Re: Uranerz Energy Corporation, Nichols Ranch ISR Project, Source Materials License SUA-1597,  
Request for Additional Information on Jane Dough License Amendment (TAC No. J00726, J00875)

**Nichols Ranch ISR Project, Uranerz Energy Corporation  
Jane Dough License Amendment  
NRC Request for Additional Information**

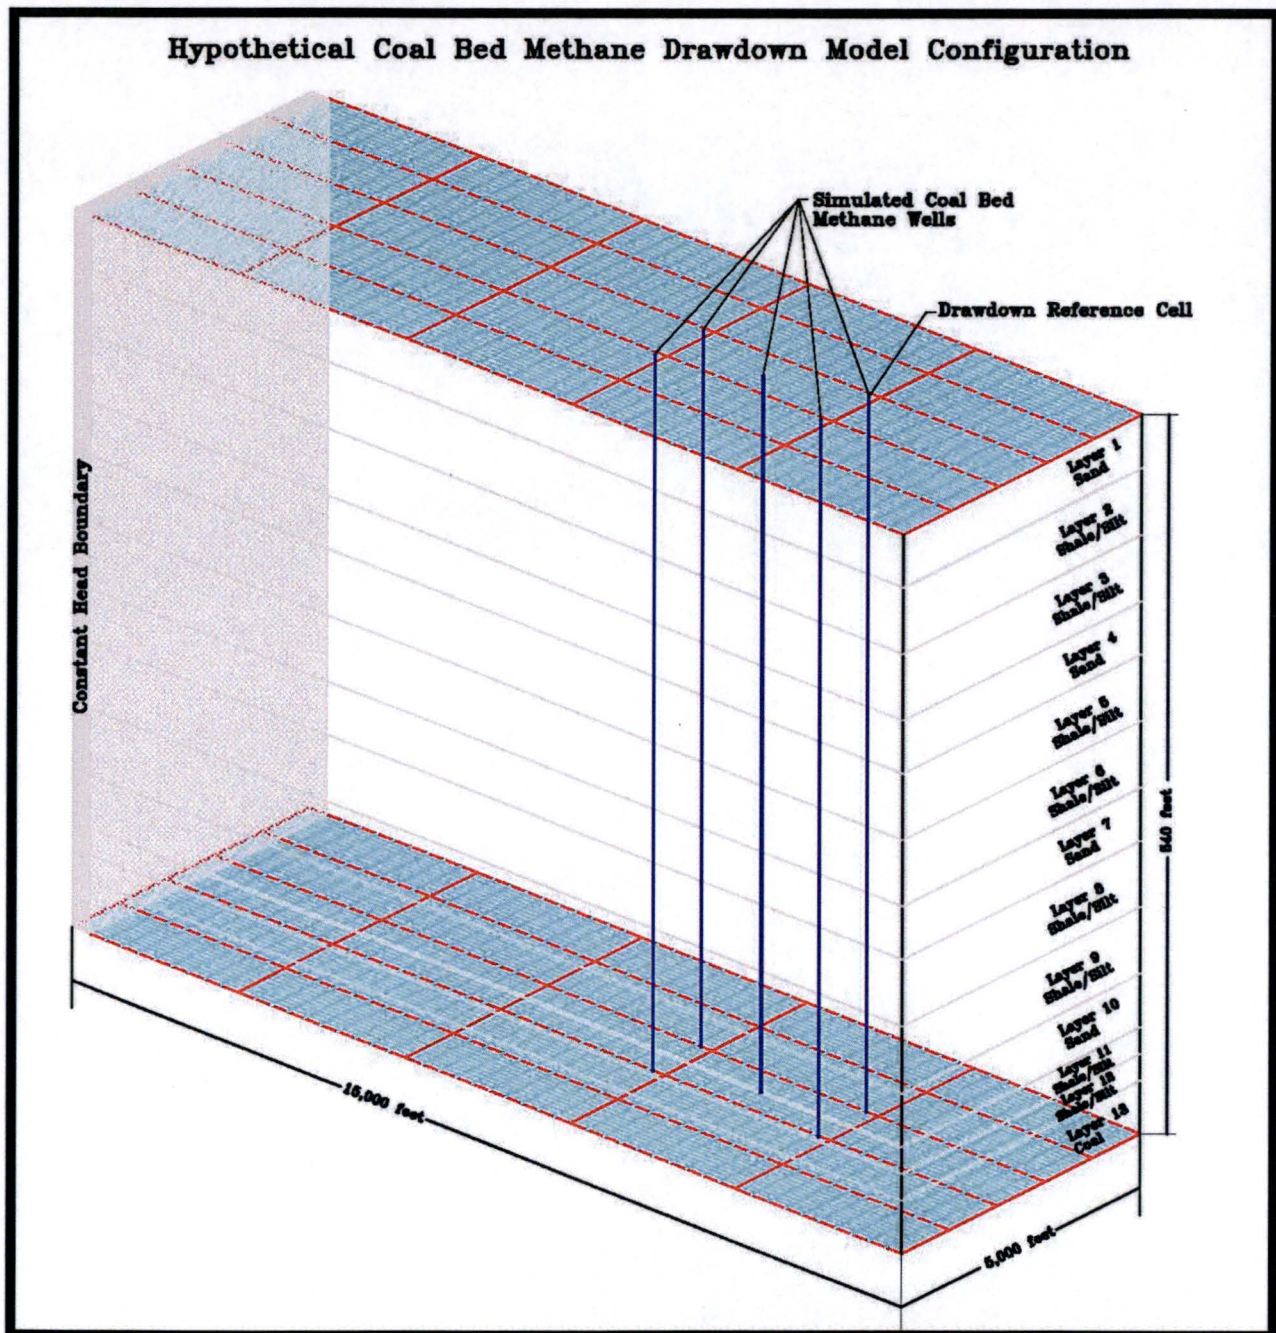
The discussion of the groundwater flow model (see page JD-D6-13) used to evaluate the potential hydrologic impacts of Coal Bed Methane production on the uranium ore-bearing sands lacks the detail required for NRC staff evaluation.

In lieu of providing model files, the following includes additional description and discussion of the analysis of the potential for impacts on water levels in the production sands by pumping of coal bed methane wells. The MODFLOW modeling used a highly generalized approach to simulate the propagation of drawdown from a hypothetical coal bed production zone up through the geologic profile to the ISR production zones. The modeling is highly generalized in that the simplified layer sequence, aquifer properties, well production rates, operational periods and other inputs were selected to produce a simulation of the expected maximum potential for propagation of drawdown vertically upward from the coal bed to the ISR production intervals. Therefore, the model inputs do

not represent a specific location, CBM well configuration or forecast of future CBM production rates. Rather, the model configuration allows simulation of a large magnitude of drawdown at a CBM production well and evaluation of the magnitude of drawdown in the strata above the coal bed.

The 50 row by 50 column model grid was developed as a strip arrangement with a 300 feet by 100 feet uniform cell dimension. A schematic of the model configuration is attached. A constant head boundary was used along column #1 of the model grid to maintain the initial head along this boundary. No other boundary conditions were incorporated in the model as the objective was to simulate a large degree of drawdown in the coal bed at the well location(s). The CBM stresses included production from five CBM wells located as shown on the attached schematic.

Because the objective of the CBM modeling was to simulate the vertical propagation of drawdown upward from the produced coal bed, the simulation results presented in Figure JD-D6-13 are for a model cell containing a producing CBM well. The focus of the evaluation on the changes in head in all layers at a cell containing a CBM well reduces the sensitivity of the modeling approach to boundary conditions, estimates of transmissivity, estimates of storage properties, and other model inputs. In short, the evaluation of head changes in all layers at the particular cell is intended to illustrate how head changes or drawdown diminishes with increasing vertical distance from the coal bed. Since the selected cell represents the maximum drawdown within the coal bed, the model results as presented in Figure JD-D6-13 represent the maximum expected drawdown in the generalized lithology above the hypothetical coal bed.

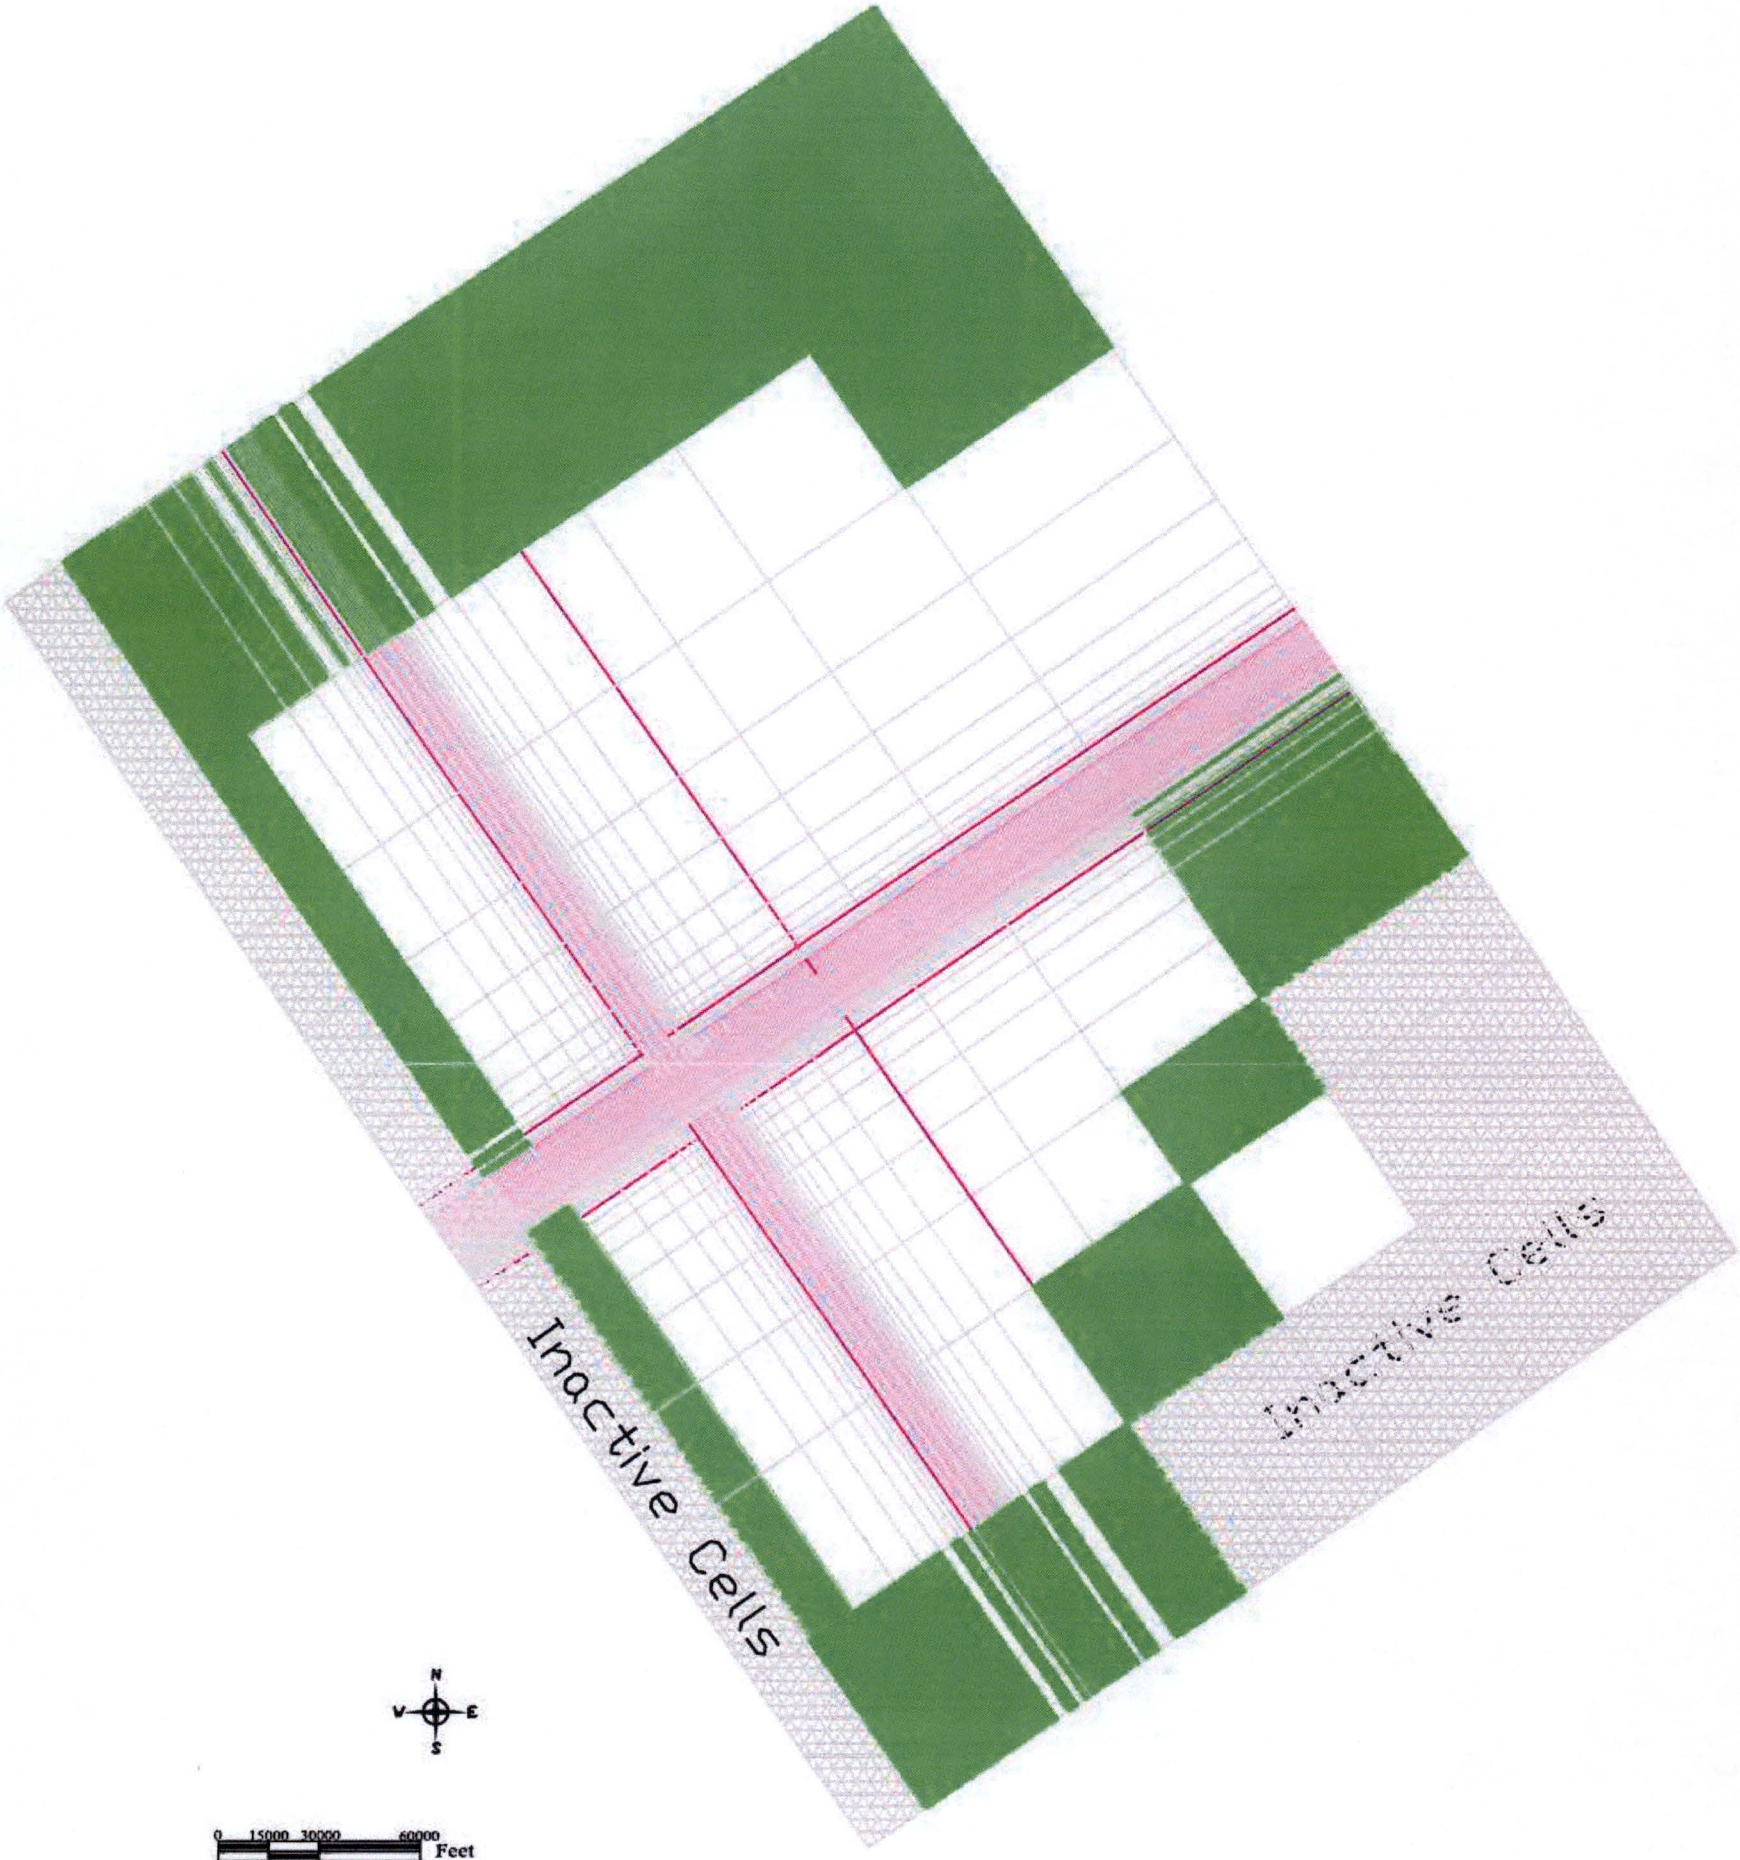
- i. Please provide a figure illustrating the assignment of the differing VCONT values within the model domain.
- j. Page MPI.2 states that model Layer 1 represents the lower interval of the B Sand. Please provide a discussion detailing the rationale for not representing the entire B Sand thickness in the model.
- k. Please provide an annotated table detailing the injection/pumping schedule for each of the 20 stress periods modeled (e.g. Nichols Ranch production Area #1 mining, Jane Dough PA #2 restoration middle ore zone etc.).
- l. Please provide any other reports that were prepared documenting the groundwater modeling simulations.

the estimate with the mudstone present. As with the estimation of VCONT above, the restriction of vertical flow represented by VCONT is almost entirely a function of the presence of the low permeability fine-grained layers within the sands.

For the remaining layer interfaces, the restriction of vertical flow is expected to be a result of low permeability layers within and between the model layers. A calculation using a composite thickness of a few feet (two to three feet) of low permeability material (estimated vertical hydraulic conductivity of  $2.8E-06$  feet/day) that restricts vertical flow within and between the model layers gives an estimated VCONT of approximately  $1E-06$  day<sup>-1</sup>.

- i. A figure titled 'VCONT Values Used in Modeling' showing the location of the increased VCONT in the area where the AB mudstone is absent is attached.

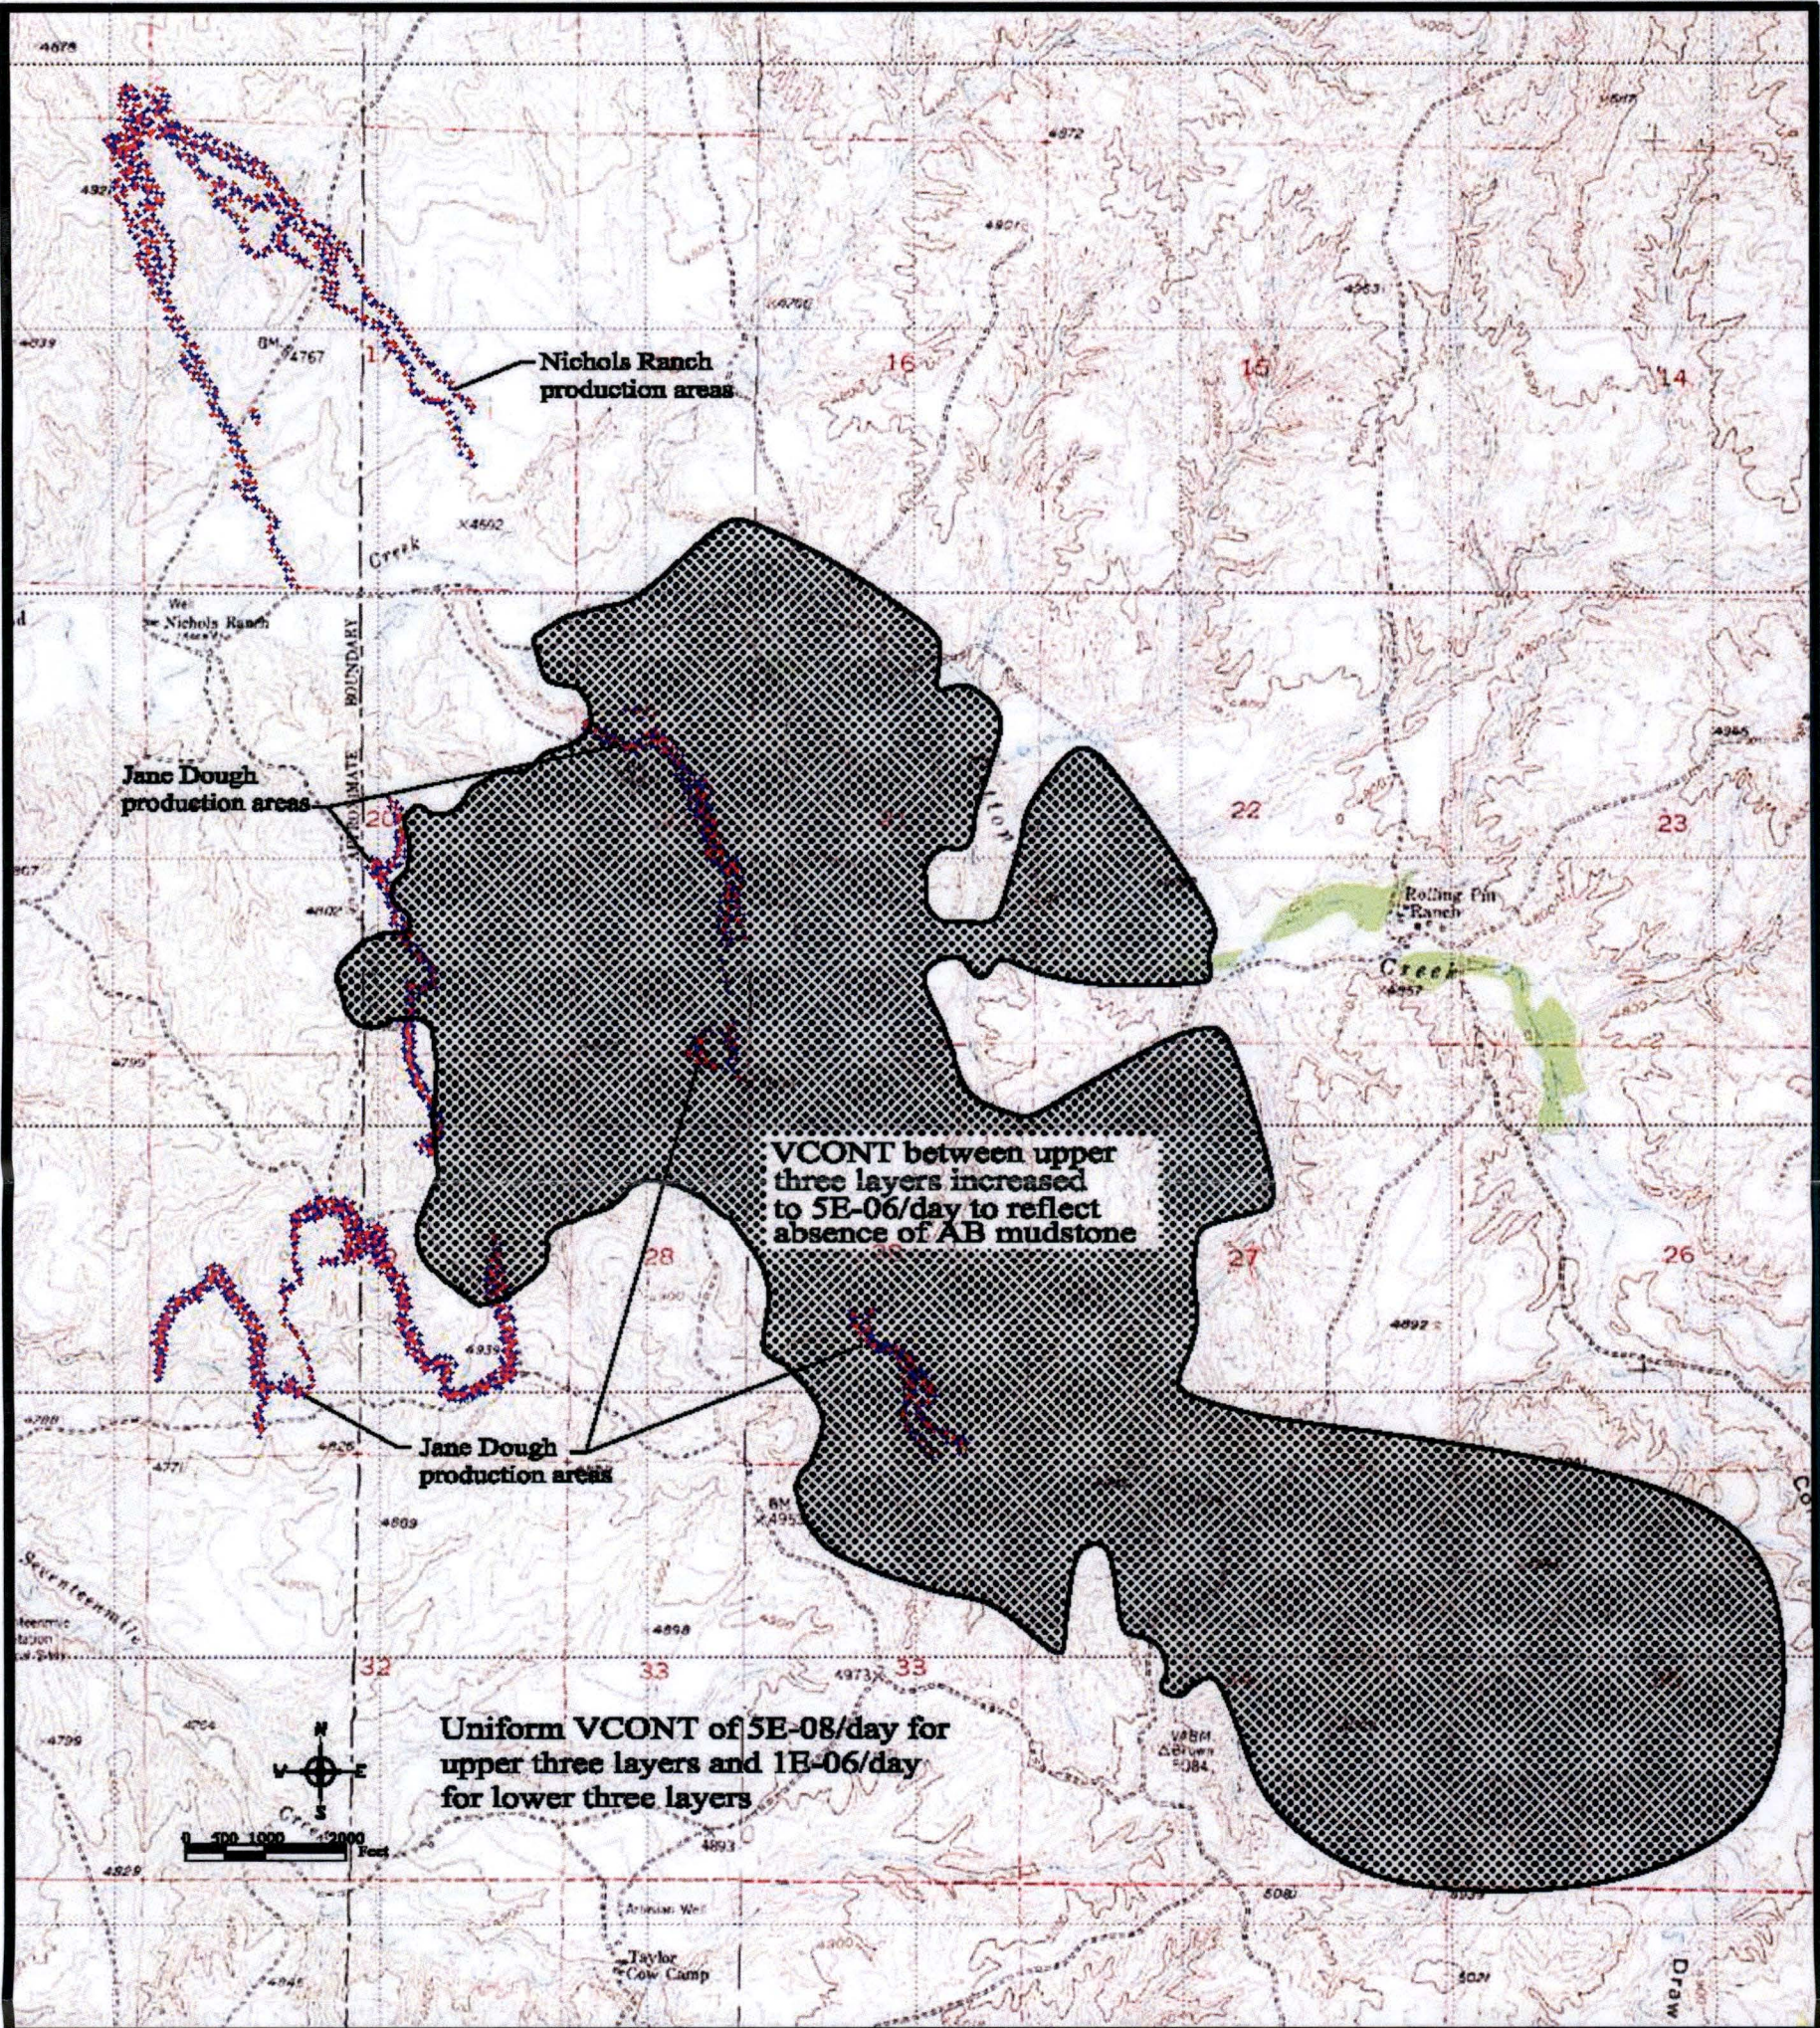
Groundwater modeling was conducted to evaluate the impacts on the groundwater flow system due to operations at the Jane Dough Unit. The description of this modeling, presented in Addendum 3D, lacks sufficient detail for the NRC staff to evaluate its adequacy.

<div> Legend Injection Well</div> <div> Extraction Well</div>	<div>REVISIONS</div>	No.	DATE	MADE BY	DESCRIPTION	<div>HYDRO-ENGINEERING L.L.C.</div>	<div><b>Uranerz</b> ENERGY CORPORATION 1701 East "E" Street P.O. Box 60680 Casper, Wyoming 82606-0680</div>
		1					
		2					
		3					
		4					
	DATE	DRAWN BY	CHECKED	APPROVED	<div>VCONT Values Used in Modeling</div>		
4-2016	TGM			<div>FILE: C:\PROJECTS\2015-14\UPGE\ID-MODEL-UPDATE-APRIL.DWG</div>
